U. S. Dept. of Agriculture
Soil Conservation Service
Engineering Division
Design Branch

DESIGN NOTE NO. 3

Subject: Detail of Riprap Above Berm on Earth Dam

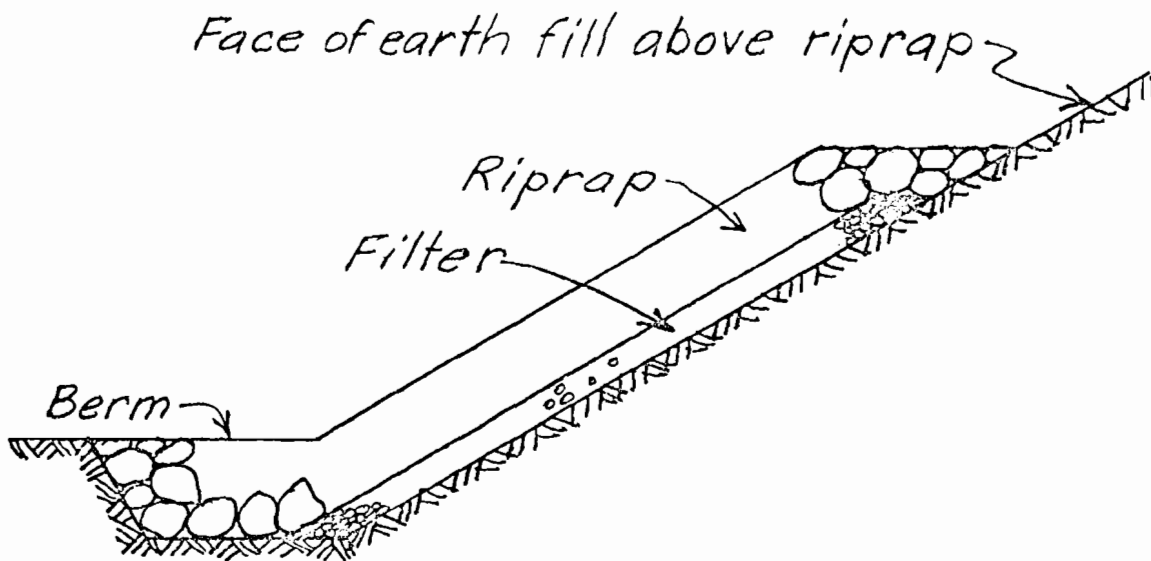
Advisory ENG-72 issued December 16, 1965, discussed a problem brought to our attention via the SCS-AGC Liaison Committee. It recommended the use of a riprap detail such as shown in the attached drawing as (b) ACCEPTABLE DETAIL.

This matter was brought to our attention again at a recent meeting of the SCS-AGC Liaison Committee. The detail shown in view (a) is still being shown on some SCS drawings for relatively thin riprap blankets on earth dam slopes. Obviously, the detail requires that placement of earth fill be halted at the elevation at top of riprap until all of the filter and riprap have been placed. Detail (a) unjustifiably restricts the construction sequence since the detail shown in view (b) is equally functional and does not apply the same restriction.

It is strongly recommended that details for riprap generally conform to the layout illustrated in detail (b) and that all plans, regardless of the date of preparation, be revised if necessary to conform to this recommendation.
